# LOS RIOS COMMUNITY COLLEGE DISTRICT

## ADDENDUM NO. 1

### DISTRICTWIDE FURNITURE AND RELATED SERVICES

### LRCCD BID NO. 19017

TYPICAL A, LEVEL 2

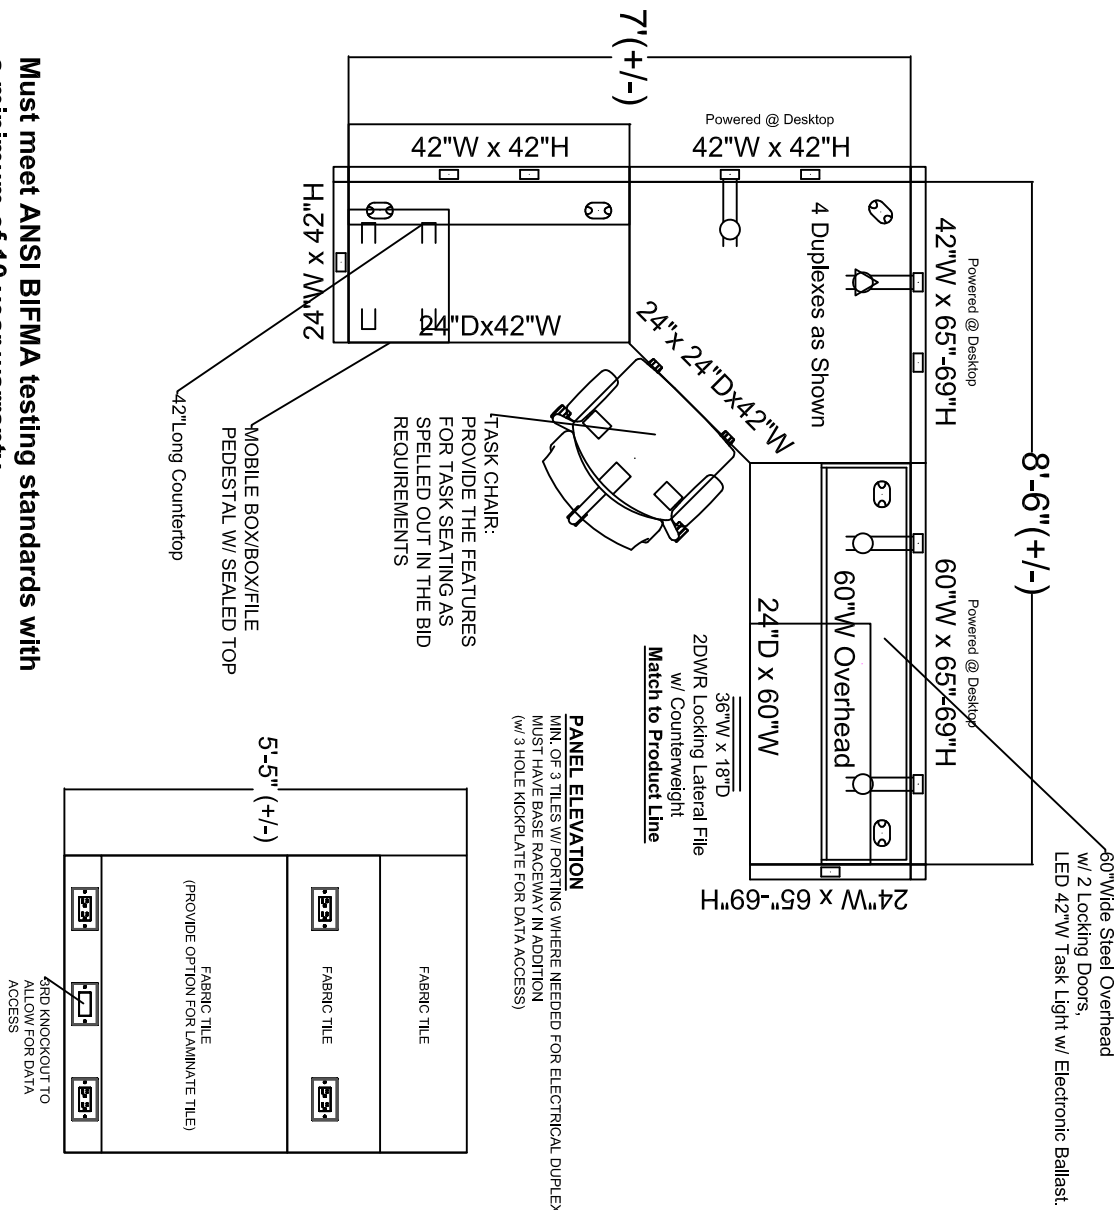
4. Ports for monolithic designs were discussed. Is one tall tile with ports required or can a port pop-up be on the desktop?  
***Yes. This modification only applies to typical A2. See revised typical for pop-up port requirements.***

- Pricing to include electrified base raceway with four (4) duplex outlets spaced as shown and two (2) desktop pop up port where shown. Desktop Pop Up Port must have clamp or flush mounted capabilities and consist of two (2) power receptacles and a minimum of two (2) USB Hubs.
